VIDAL ST. S.

C.N.R. OVERPASS

REVIEW OF REPORT BY RACEY,  
MAC CALLUM & ASSOC., and  
PRELIMINARY PLAN BY DAMAS AND

Re: Soil Investigation, C.N.R.  
Overpass, Vidal Street South,  
Barnia, Ont. (D.H.C. Dist. #1)

## LAYOUT OF APPROACHES

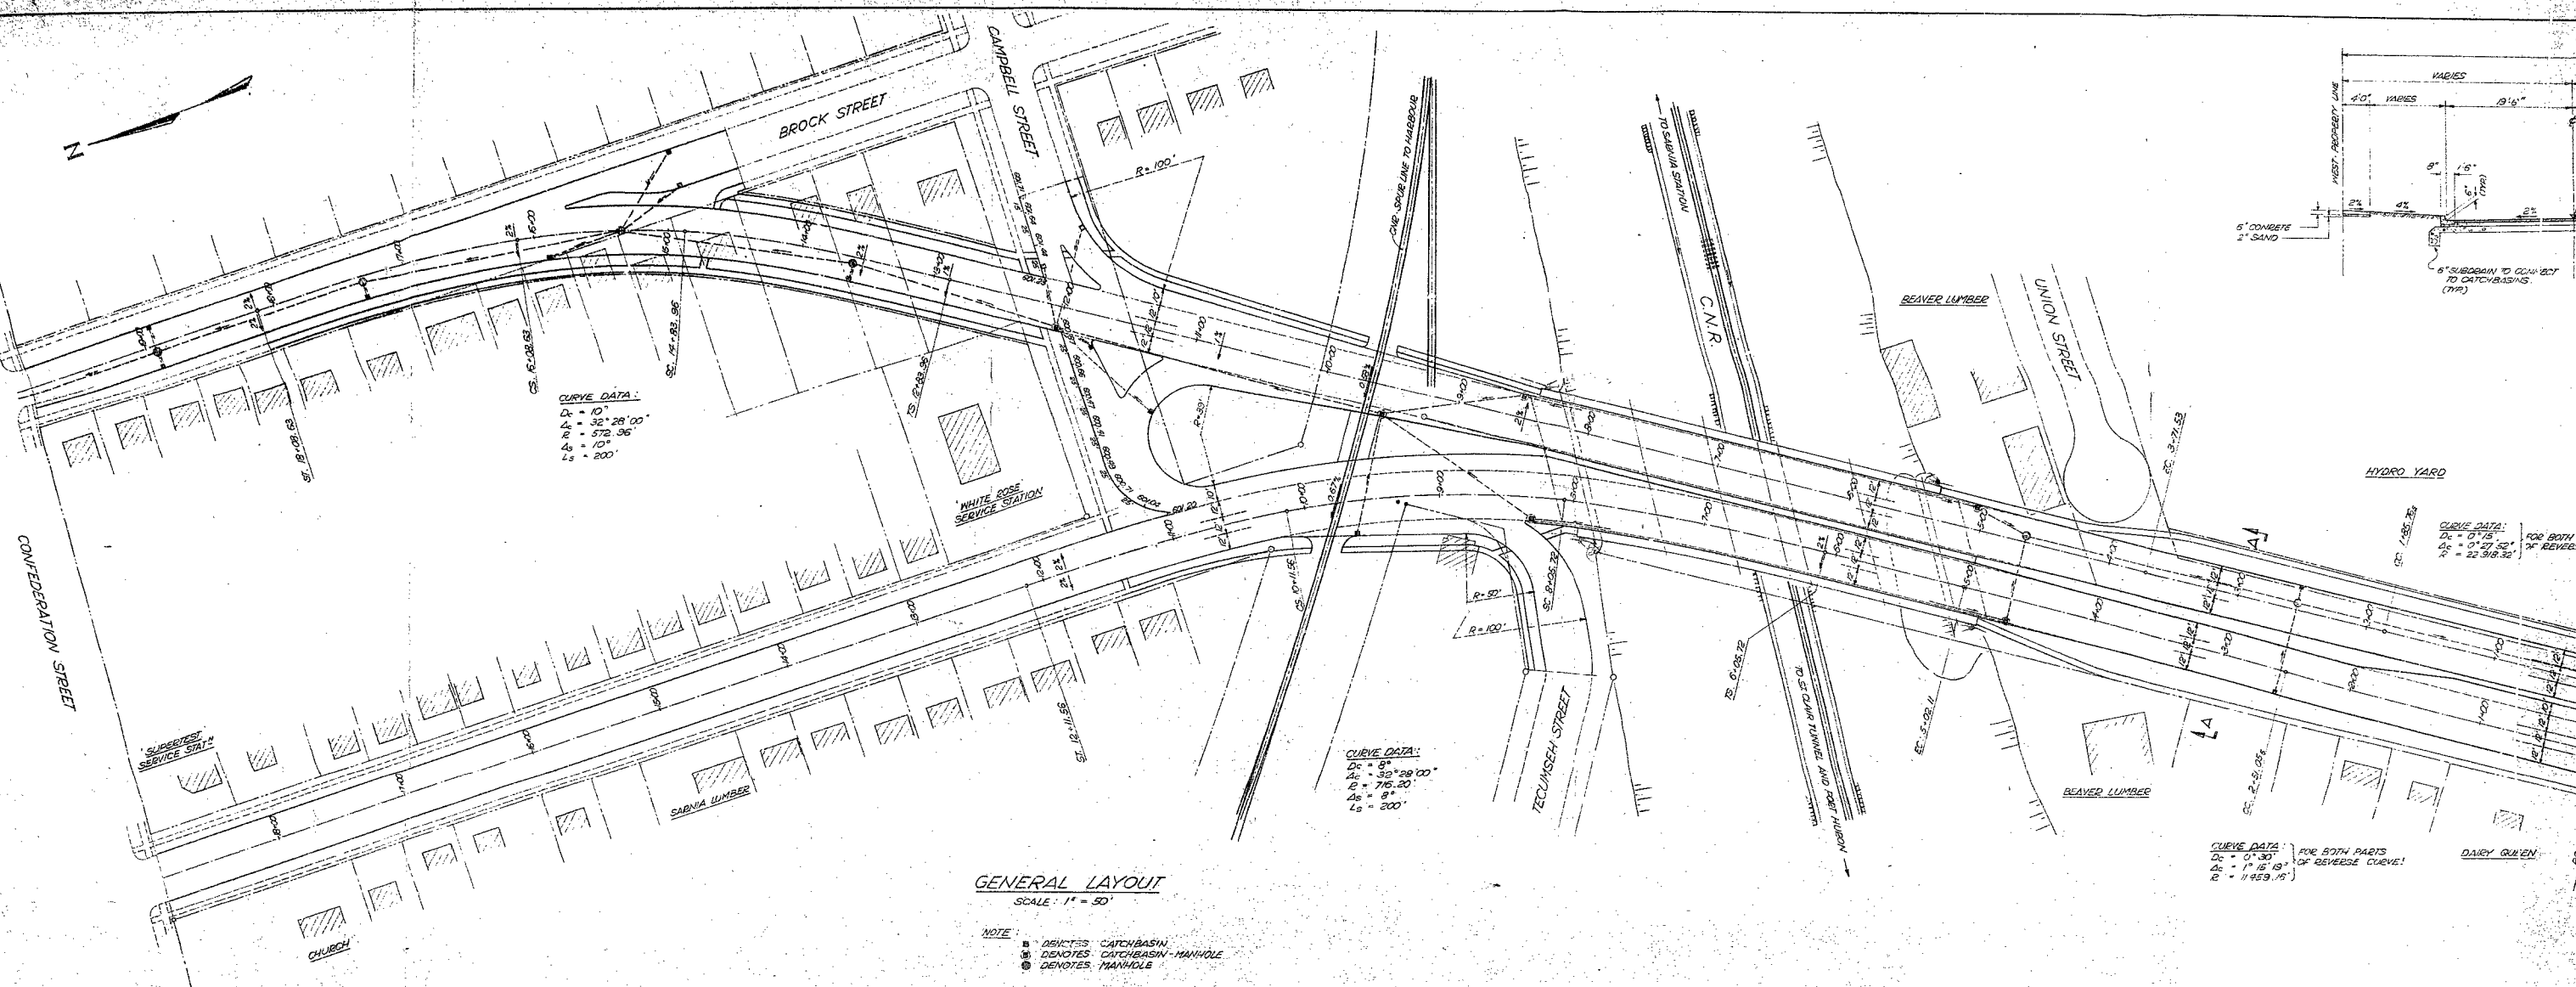
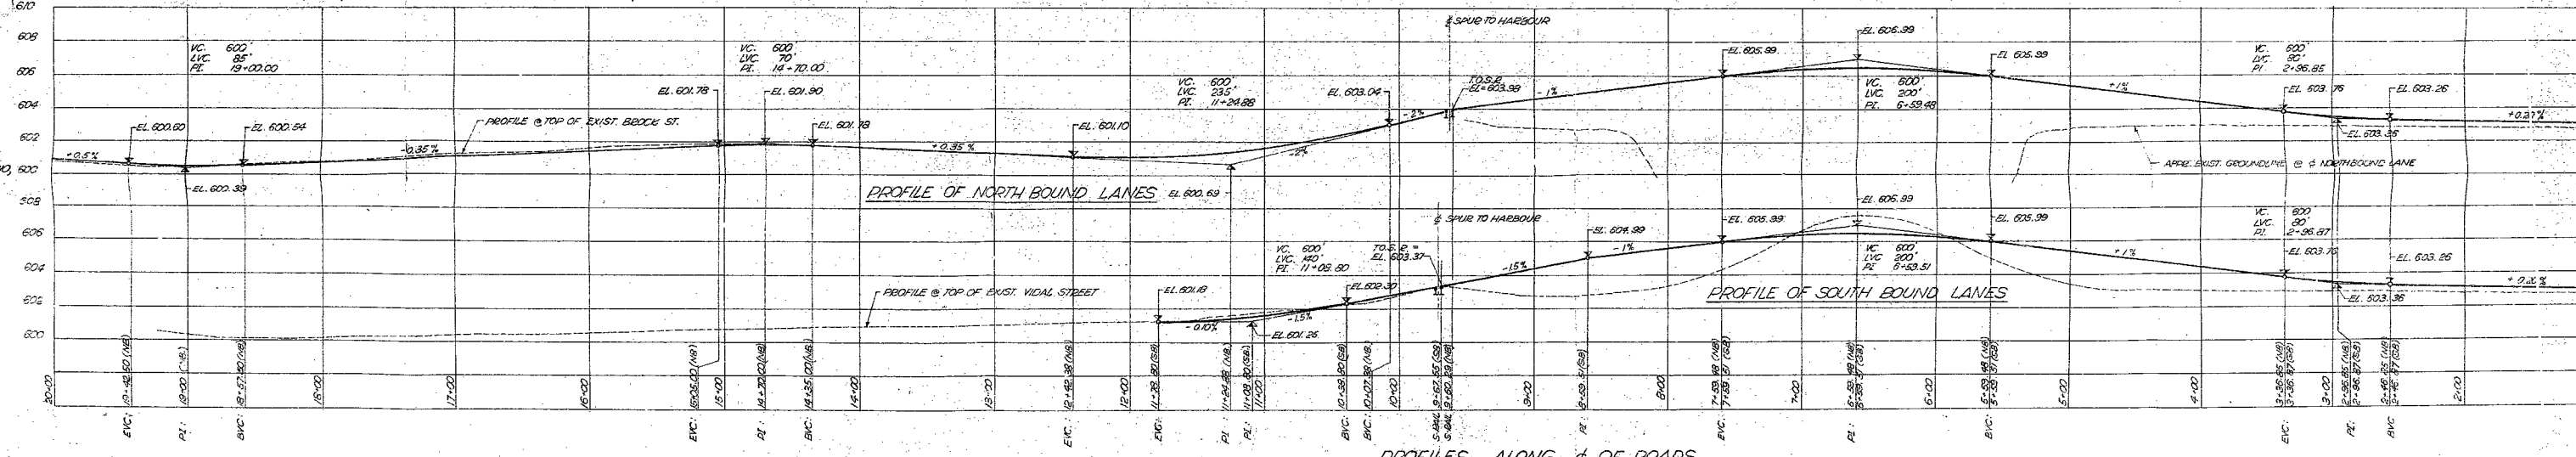
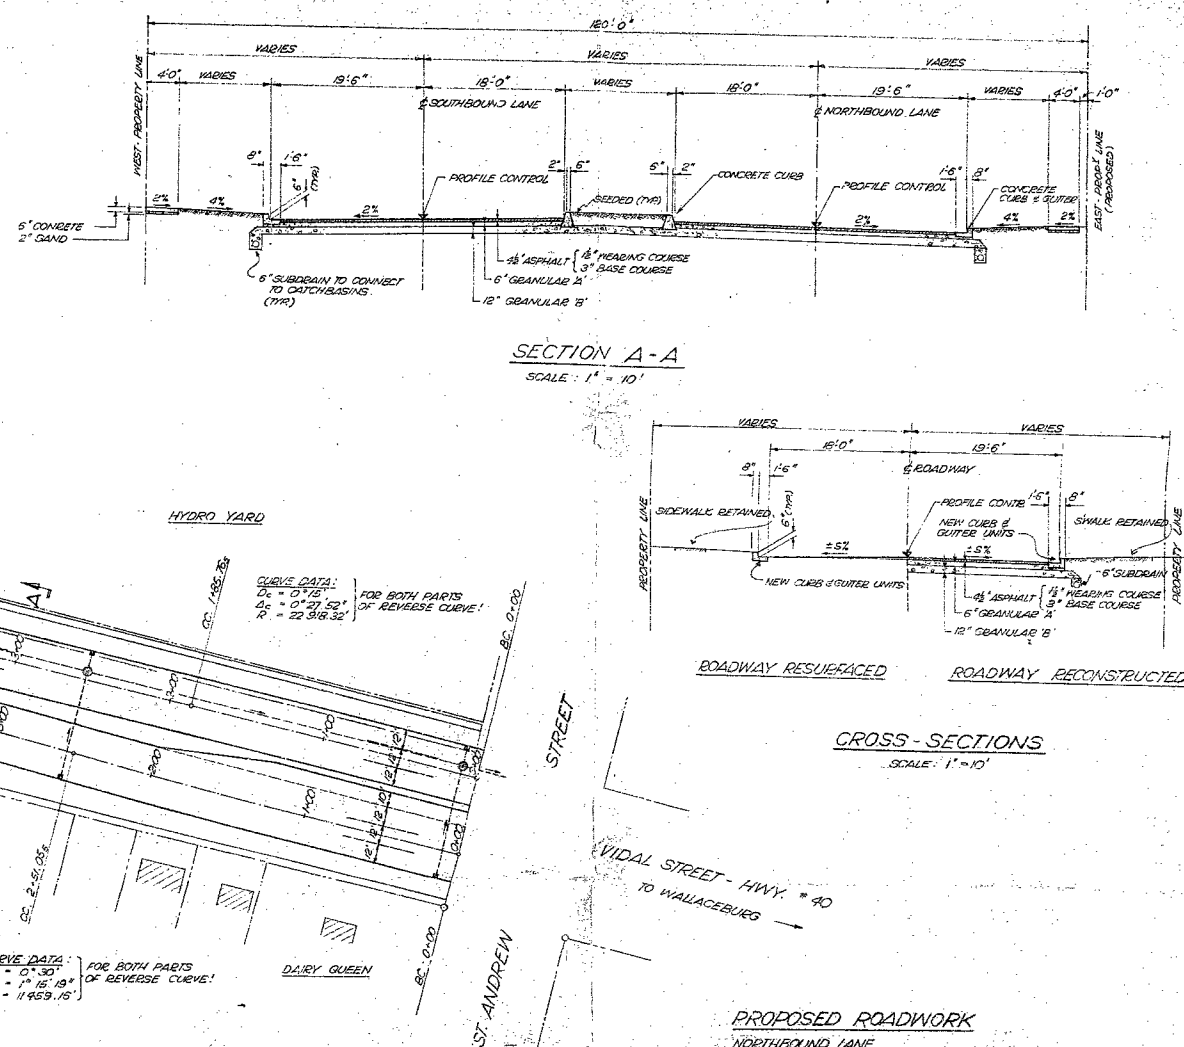
The final recommendation of the soil consultant, and accepted by the bridge designer, is to use piled foundations for the new structure. This recommendation is based not on the inadequate safe bearing capacity, but on the fact that the settlements will be too great. A calculation presented in the report gives 5.29" as the maximum settlement.

An additional settlement calculation was carried out in this office taking a load of 2,300 p.s.f. (the Consultant used 2,500 p.s.f. in his calculation), and using the same two compression curves. The value obtained was 4.37" which was then corrected for overconsolidation and a final value of 2.6" was arrived at.

The above final value represents, in our opinion, the maximum possible consolidation settlement based on the two compression curves given in the report. We are not in the position to evaluate to what extent these two curves are representative for the particular subsoil, and are therefore unable to dispute the above given settlement figures. However, we are of the opinion

that they represent a maximum and that very likely, much smaller settlements will take place. This opinion of ours is based on the following information and its interpretation:-

It is a known fact that the railway cut was excavated some 60 - 70 years ago. Prior to that, the ground surface was relatively flat and had a general elevation of about 605. The cut bottom elevation under the present bridge is 565 which means that approximately 40 ft. of overburden was removed. If we assume that 20 ft. of that material was submerged, we get an approximate load that was acting on the soil at elevation 565 as:

This load was removed and the soil has rebounded. Any new load that would be put on the soil and would be less than the one removed, and under which the soil was consolidated, should cause only very small settlements. Greater settlements could only be expected if the soil is of a swelling nature.

In this particular case, a load of 2,300 p.s.f. is added, which is quite smaller than the preconsolidation load and therefore, the settlements should be very small. For the piers placed at mid-height of the present cut, where the overconsolidation pressure is only 2,400 p.s.f., the new load would be only slightly smaller and, again, the settlements should be small. As to the abutments, settlements should be also very small because the footings would be placed within the upper desiccated crust which is much less compressible than the deeper layers.

The above reasoning certainly points to the possibility that the settlements will be smaller than the computed ones, and we would therefore recommend that spread footings be used. We would also like to point out that by the use of friction piles, settlements are not eliminated: sometimes, not even reduced. In this particular case, since the properties of the subsoil do not improve appreciably with depth, the reduction may be insignificant. It is also our opinion that spread footings could be used even if the settlements would be in the order of 2 - 3 inches, because the differential settlements, the ones that are to be considered, would not be more than 1-2 inches. Such differential settlements could be taken without damage by the proposed structure.
